To Whom It May Concern:

Throughout the process of updating and granting zoning for Jolina Court development, I've been highly concerned about changes and damage to the wetland and floodplain south of the farm access road. This is the farm access road that connects the Town Center parking lot to the Jericho Settlers Farm property and abuts the Buttermilk property. My concern has been that changes to that area would lead to even greater catastrophic flooding than Richmond has already come to expect and fear.

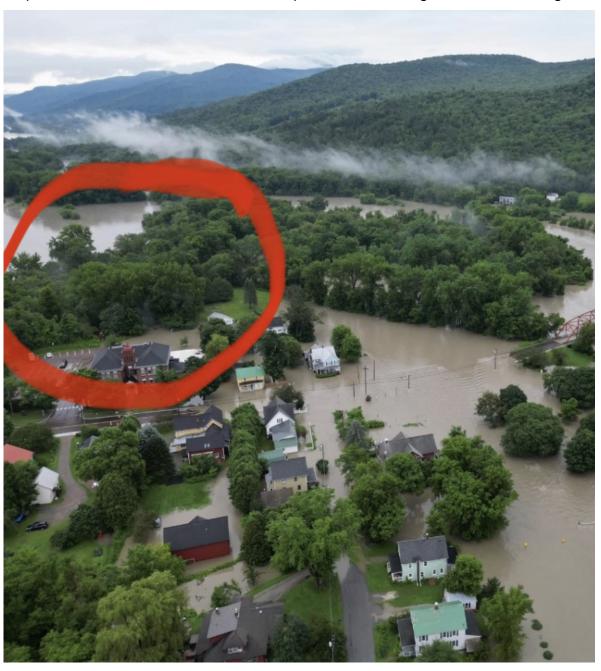
Having visited the farm access road after every storm (large and small) in the last four years, I can attest to the fact that the area to the south of the farm access road is a *highly* active floodplain. You can see in the picture below that the trees to the south of the farm access road stand directly between the river and Town Center—as well as the other part of town that are the unfortunate epicenter of flooding in Richmond village.
